COMMONWEALTH EDISON COMPANY  
Byron/Braidwood - Units 1 & 2  
Project Nos.: 4391/4392/4683/4684

Moisture Content Analysis  
For The Air Stream  
At The Inlet To Auxiliary Building  
Ventilation Exhaust Charcoal Filters

NRC QUESTIONS REGARDING

FIGURE 2-1 MOISTURE REMOVAL EFFECTIVENESS FOR  
RHR PUMP CUBICLE AREA COOLER  
(R = 9)

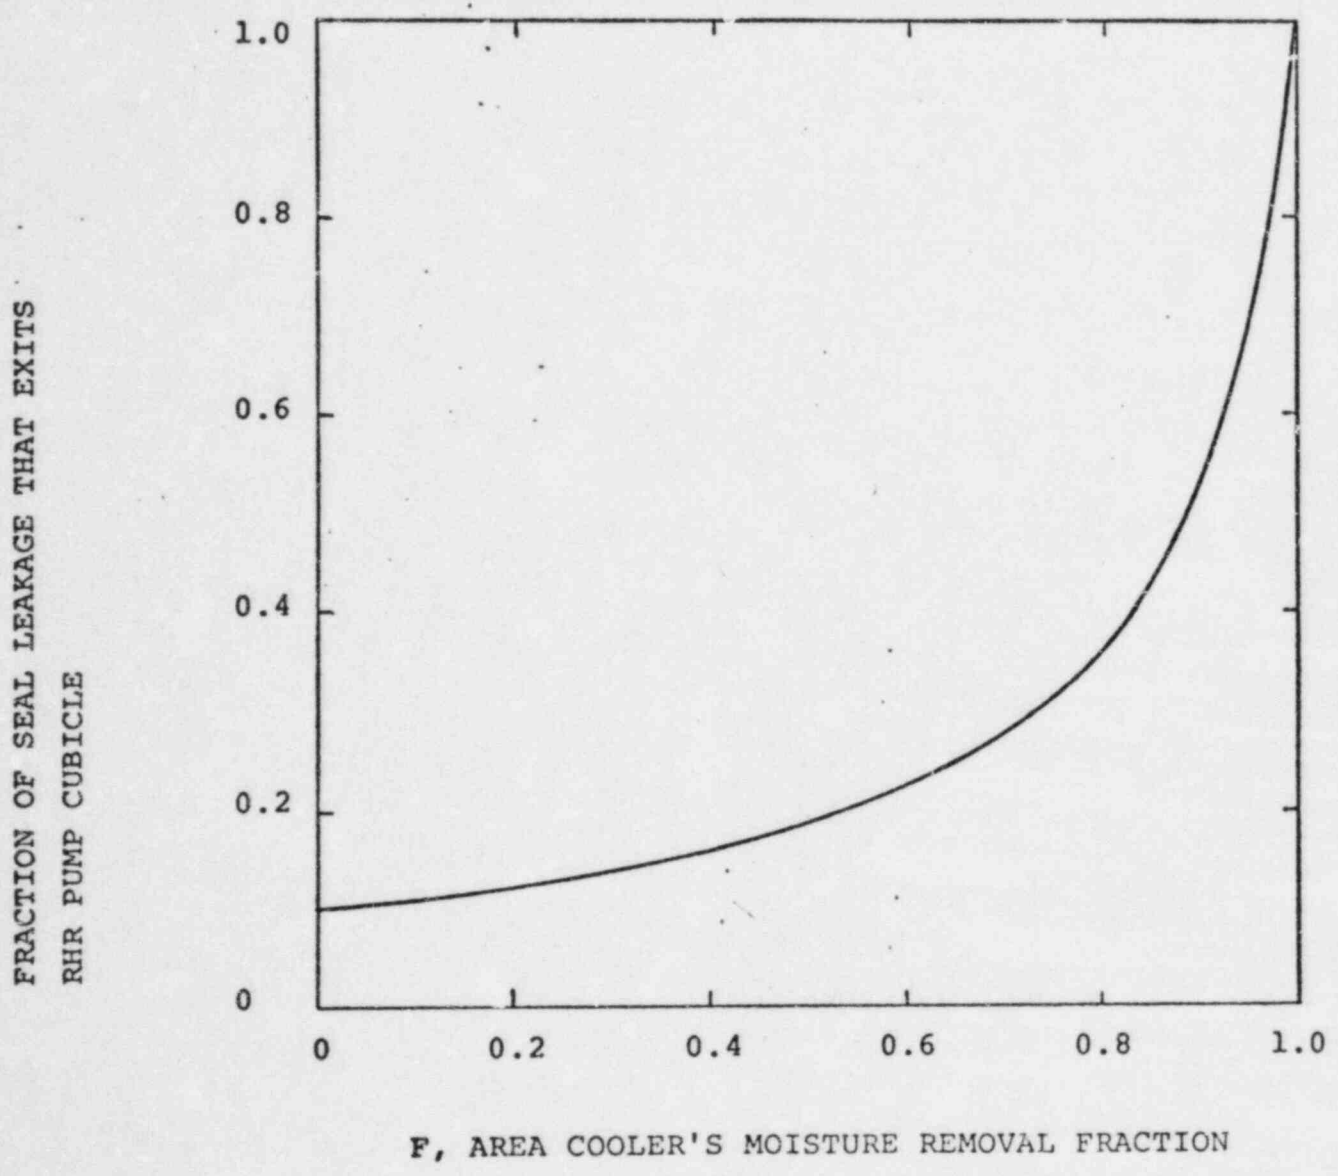
Paragraph IV.C of the analysis stated that it is assumed that all the leakage that does not flash is removed from the pump cubicle by the floor drain system. We believe this assumption is non-conservative. Revise the analysis to include a conservative assumption for vapor from a seal failure (e.g. 20%)

Figure 2-1 displays Equation 4 as a function of F, the area cooler removal fraction, and for a value of R=9 (10,154 cfm/1076 cfm).

Due to the internal configuration of the area cooler, all of the entrained moisture in its inlet stream is removed. Therefore, F is taken as zero (i.e.,  $H_2 = 0$ ), and Equation 4 states that only 10% of the seal failure moisture exits the RHR pump cubicle.

Additionally, the area cooler will condense water vapor and remove moisture by that mechanism as well. Thus, if 90% of the moisture is removed, then only 2% of the 20% suggested in Question 2 would remain. This is less than the 4% used in the reported analysis.

PLAN VIEW OF  
 RHR PUMP,  
 CUBICLE COOLER  
 & ASSOCIATED DUCT WORK

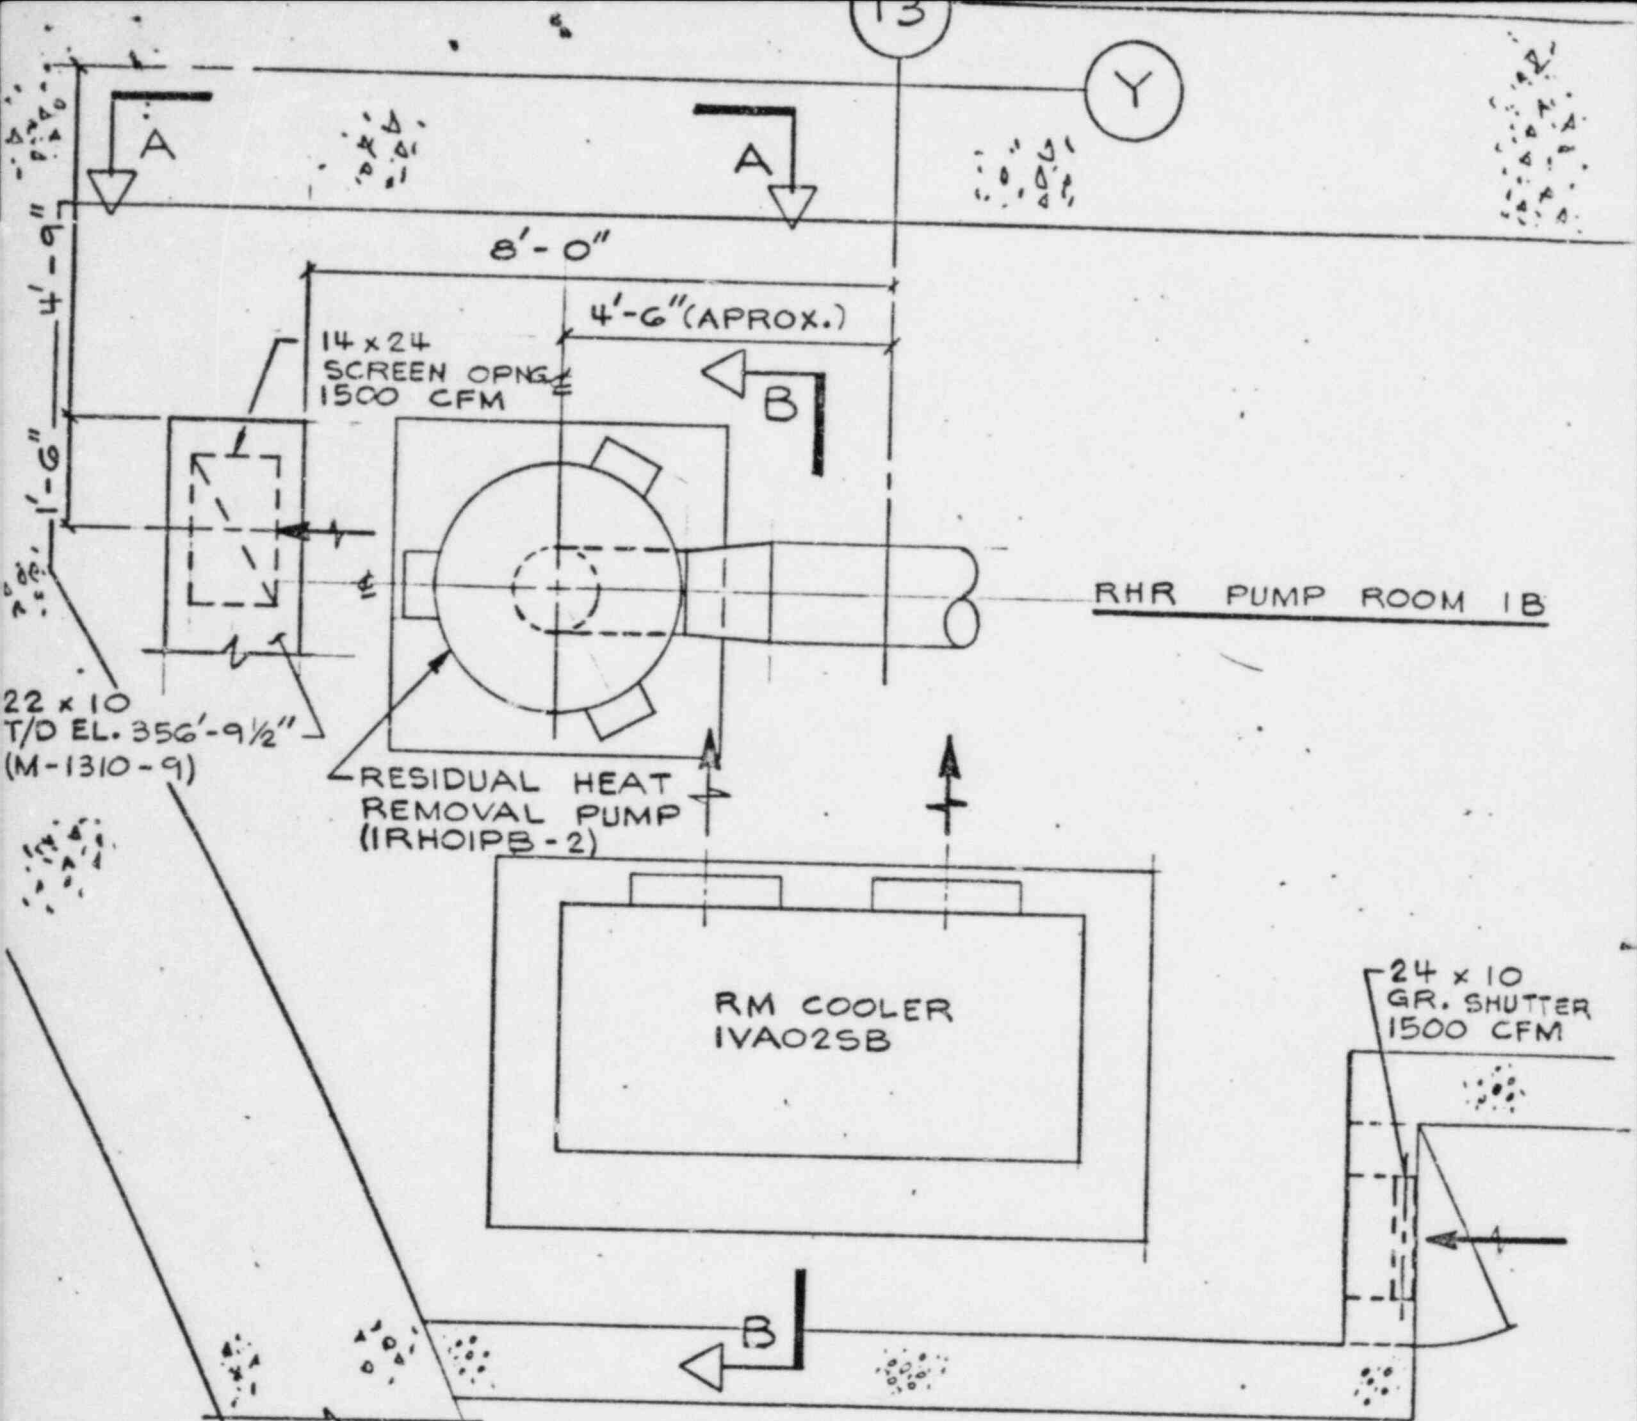
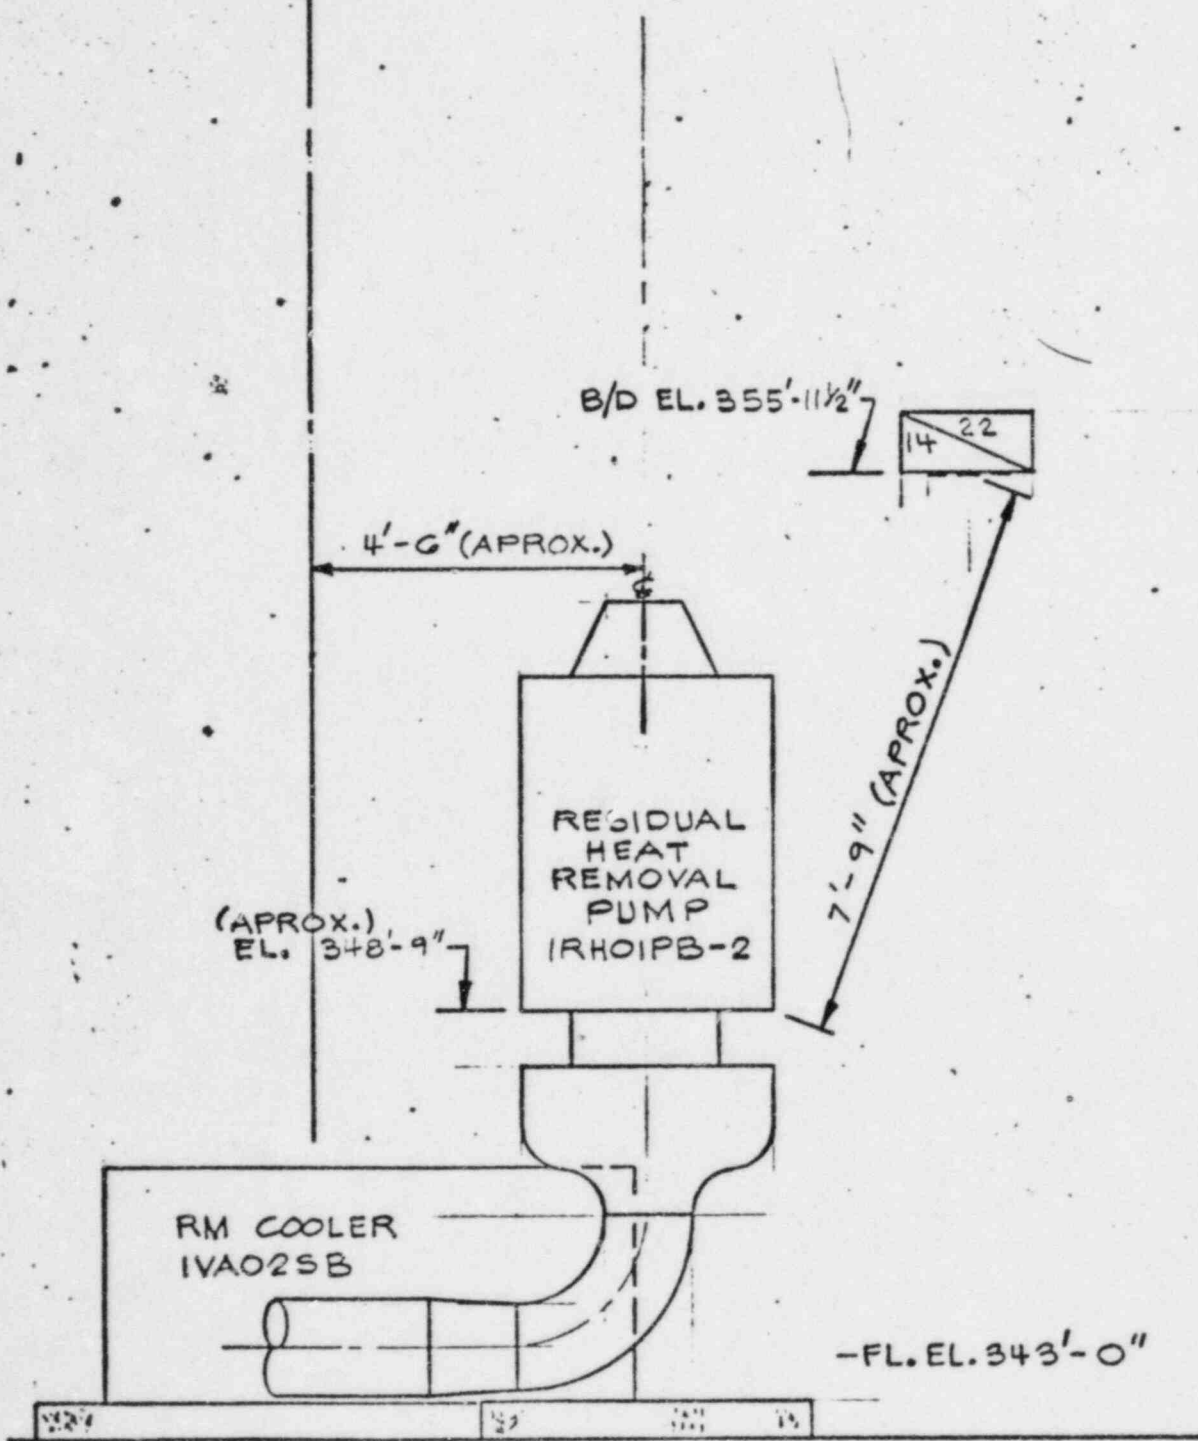
If, as a result of incorporating the comments in Question 2, you decide to include the effects of the area cooler, additional information concerning the cooler and its orientation with respect to the exhaust duct must be provided.

The attached sketches describe the location of the cubicle area cooler's suction and exhaust, the location of the ventilation exhaust inlet and the RHR pump and motor configuration. The proposed seal leakage would be at least 7'-9" away from the ventilation exhaust duct simply due to the elevation difference. Additionally, the RHR pump motor is located above the RHR pump seal and below the ventilation exhaust duct. The RHR pump motor, therefore, acts as a physical barrier. This physical barrier will inhibit spray from the proposed seal failure from directly impinging on the HVAC ducted exhaust screened opening.
